## LEGAL NOTICE EXETER PLANNING BOARD AGENDA

**Date:** December 1, 2022  
**To:** Planning Board  
**From:** Dave Sharples, Town Planner  
**Re:** Jerry & Christine Sterritt PB Case #22-14

### Assessor's Map 13, Lot 1 ISSUED FOR PLANNING BOARD

TITLE:  
**STORMWATER  
MANAGEMENT AND  
DEVELOPMENT PLAN**

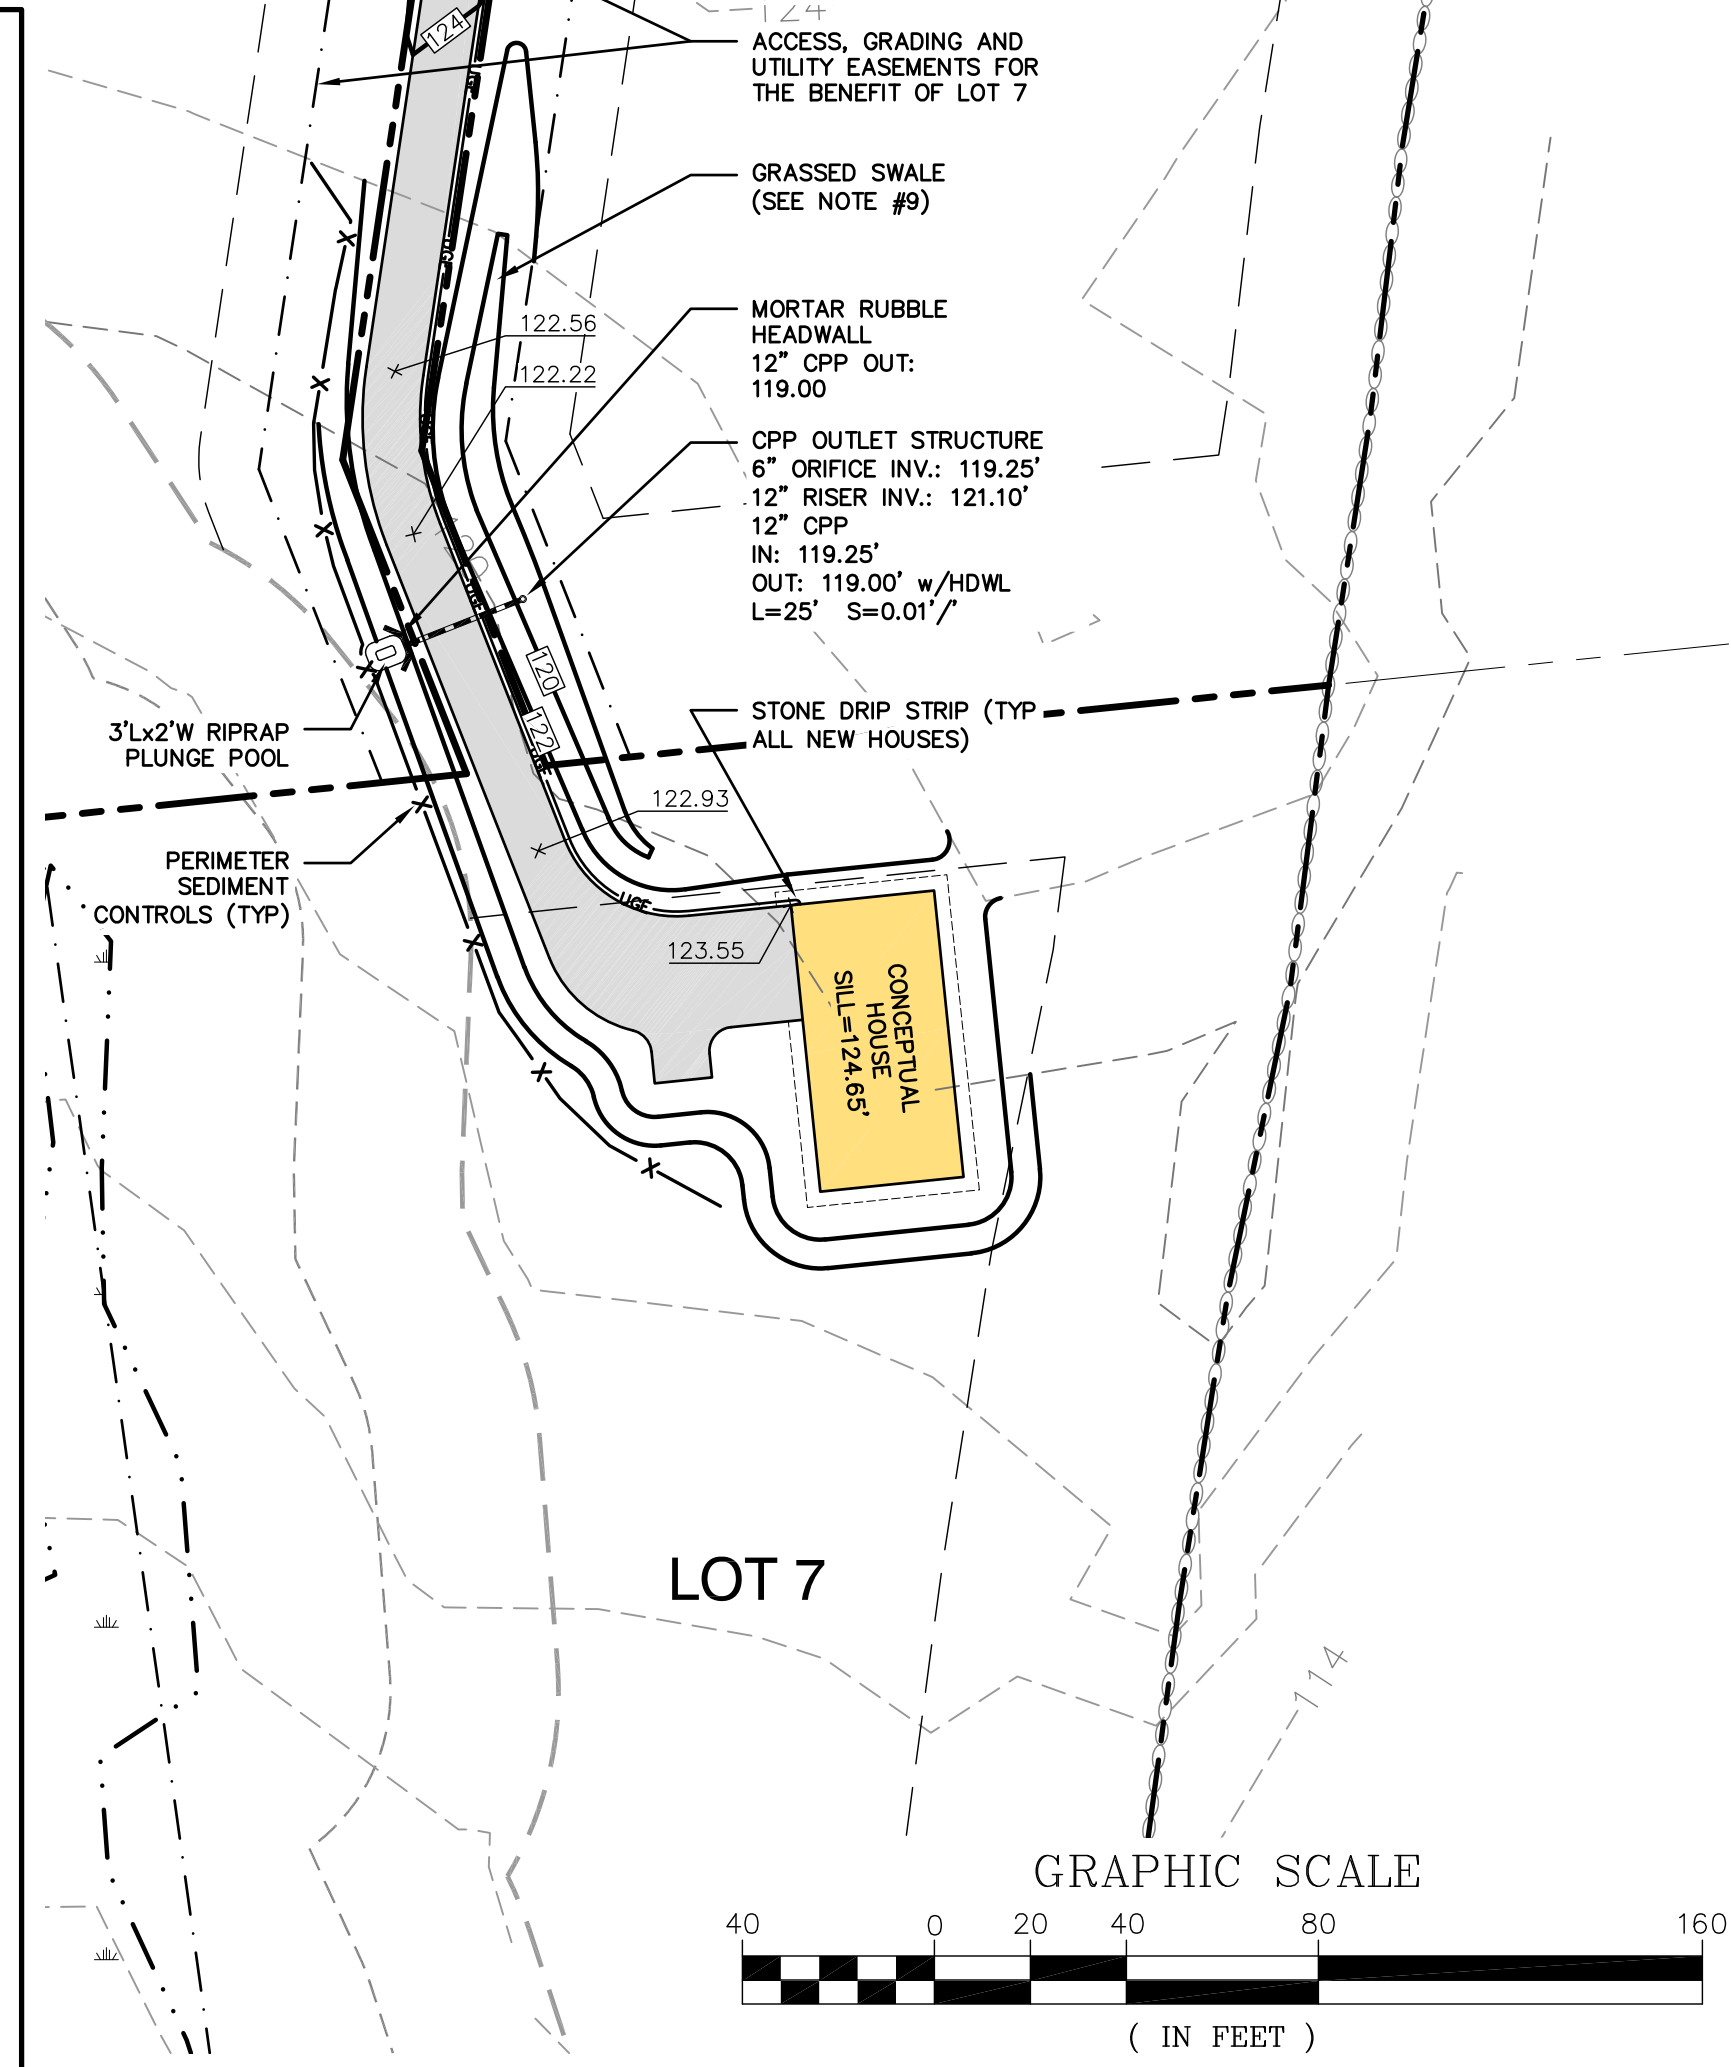
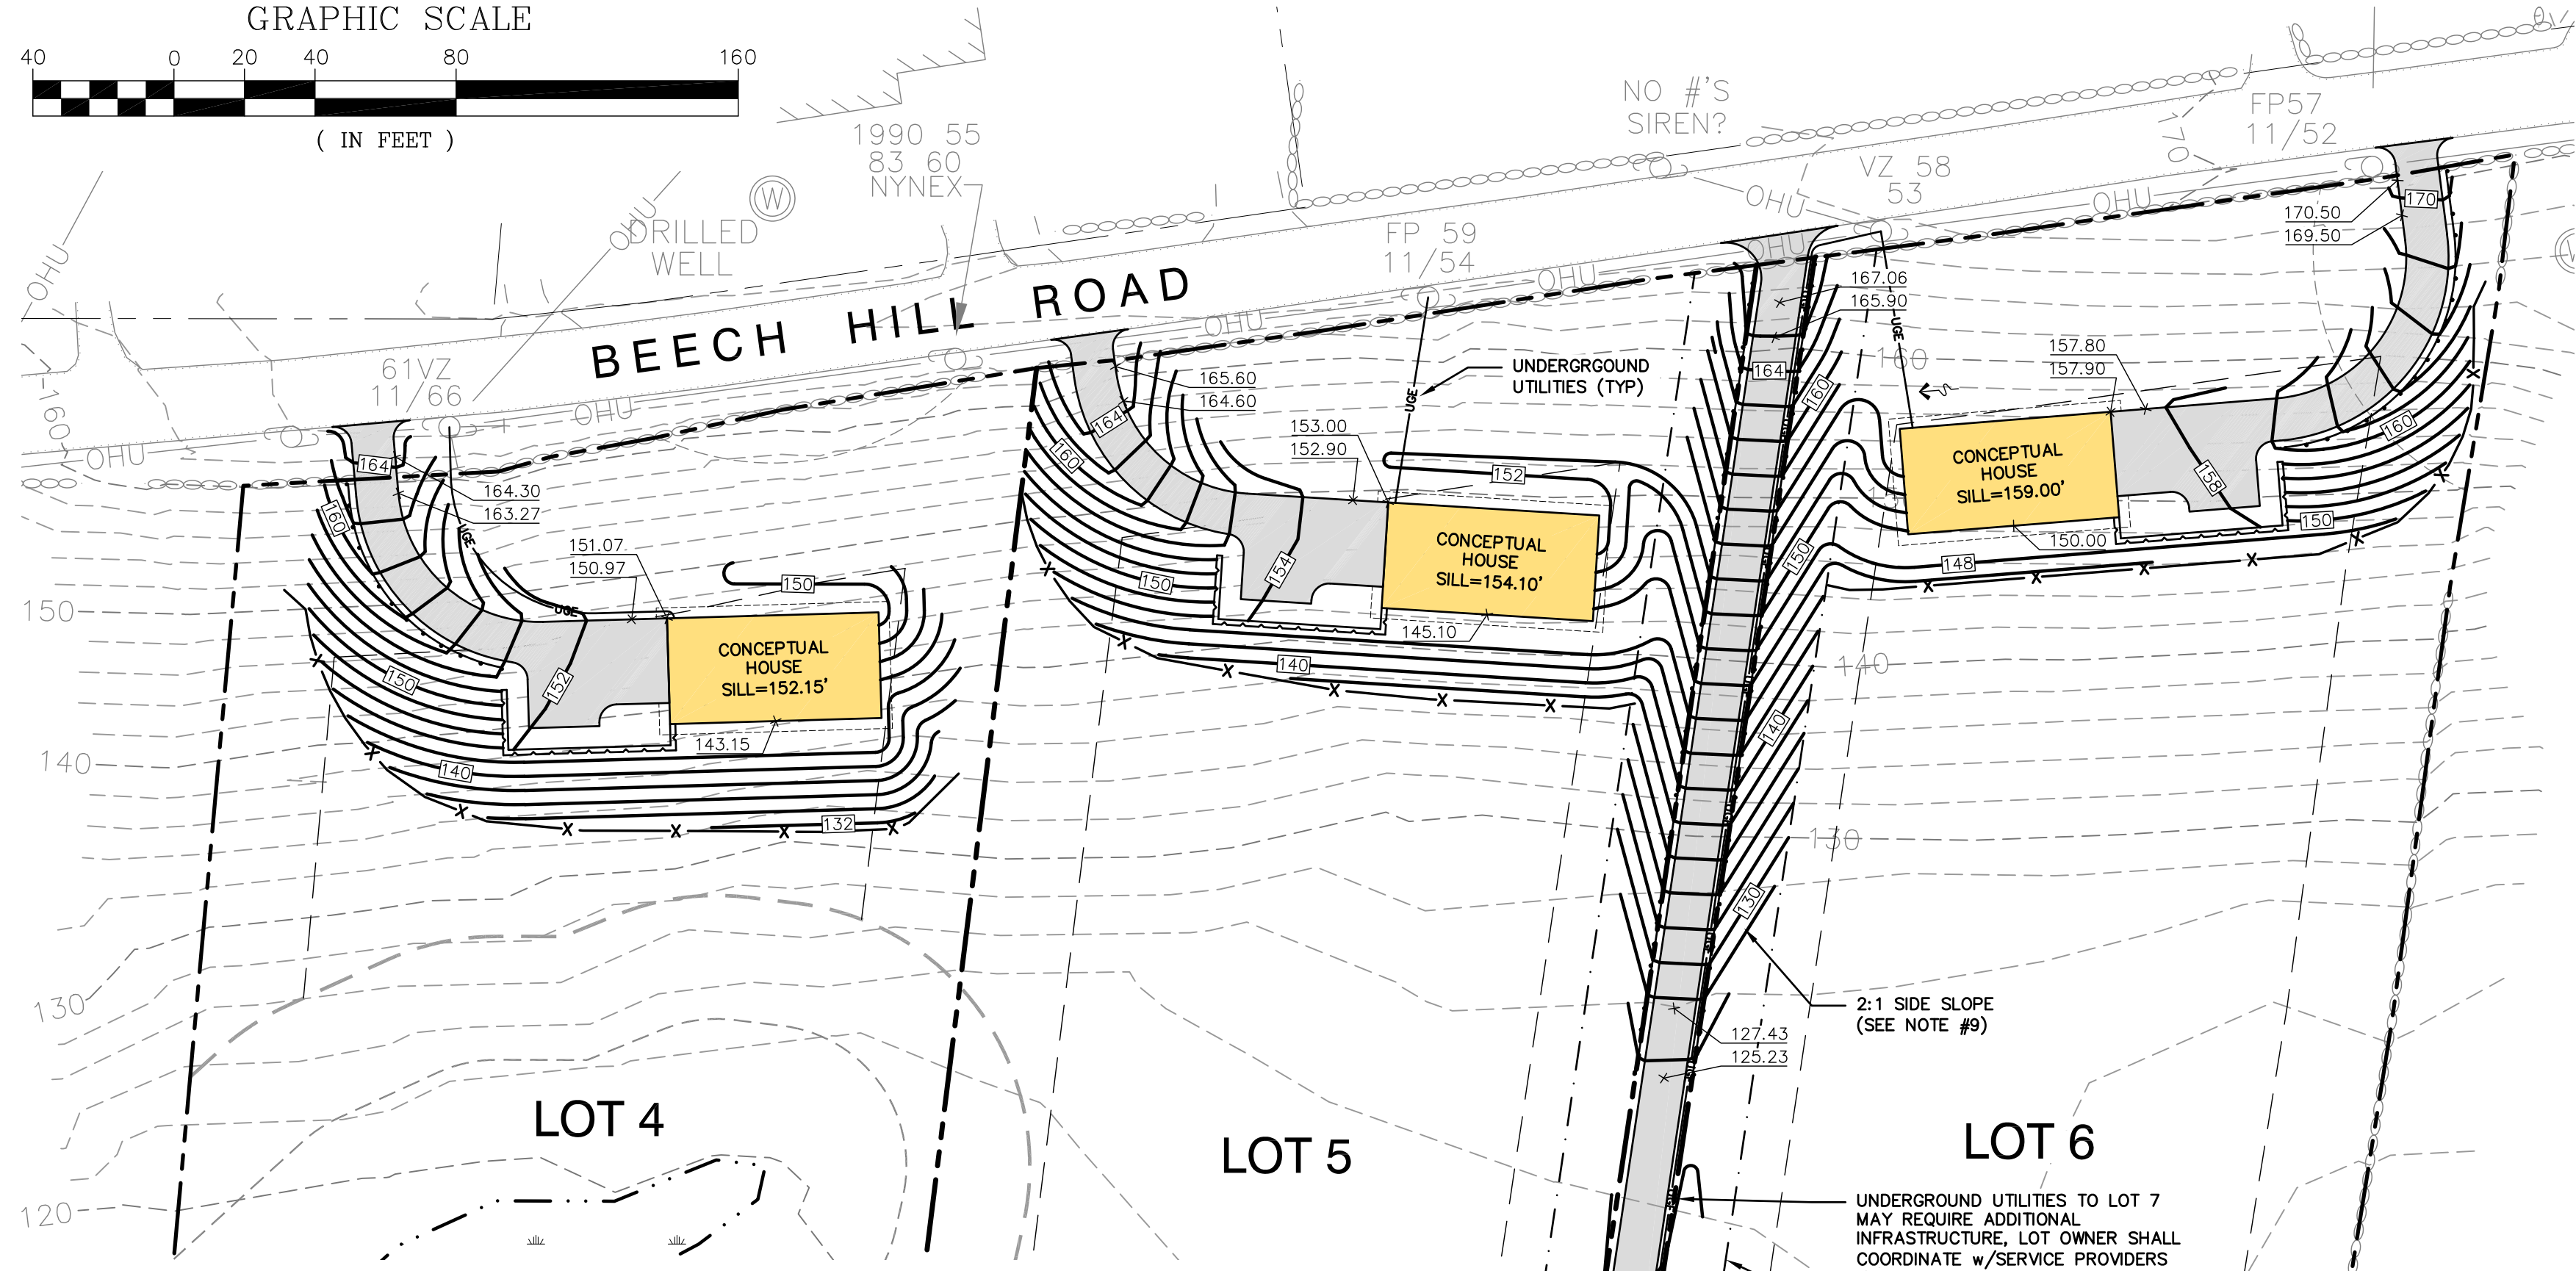
1. We note the proposed houses and driveways shown on sheet C-3 are conceptual in nature and will likely not be constructed as shown by individual landowners:

- 1d. We have added grading to the remainder of Lots 4-7 as shown on Sheet C-3.
2. Total lot frontages have been added to Sheet C-1.
3. We have extended Lot 7 to Beech Hill Road via a 16'-wide strip of land as shown on the plans.

## STONE DRIP STRIP

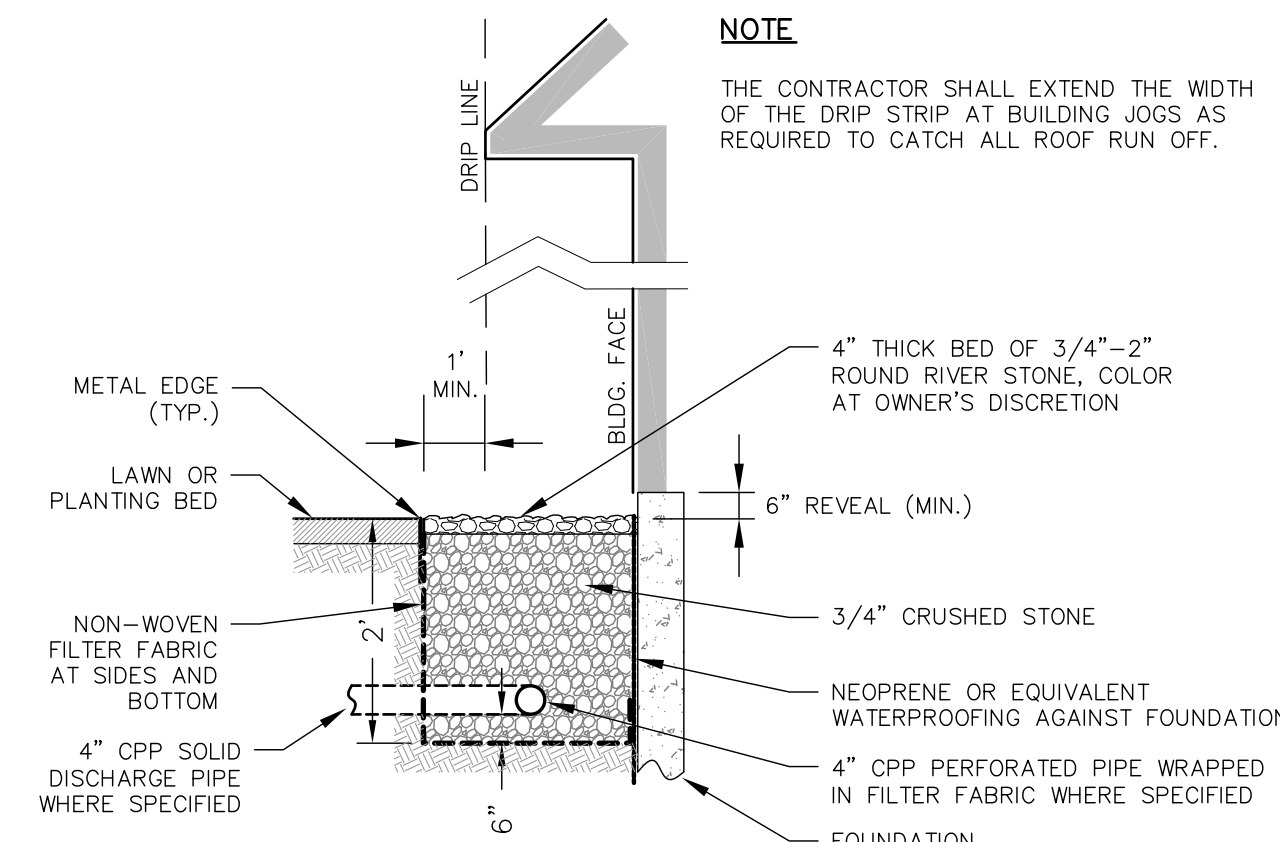
4. The parcel number on the cover page should be changed to 1.
5. Since each lot will be developed by individual landowners, how will they be directed to ensure a drip edge and plunge pool is constructed for each lot?
6. Runoff amounts should be increased by 15%.
7. **PTAP Database: This project requires registration with the PTAP Database**, the Applicant is requested to enter project related stormwater tracking information contained in the site plan application documents using the Great Bay Pollution Tracking and Accounting Program (PTAP) database ([www.unh.edu/unhsc/ptapp](http://www.unh.edu/unhsc/ptapp)) and submit the information with the resubmitted response to comments.

4. We have changed the word "parcel" to "map" on the Cover Sheet.
5. We have added Note #18 to Sheet C-1 specifying that each house is to be constructed with drip strips. As this sheet is to be recorded, this note will get captured on the mylar. In addition, this stipulation will be repeated in each deed.
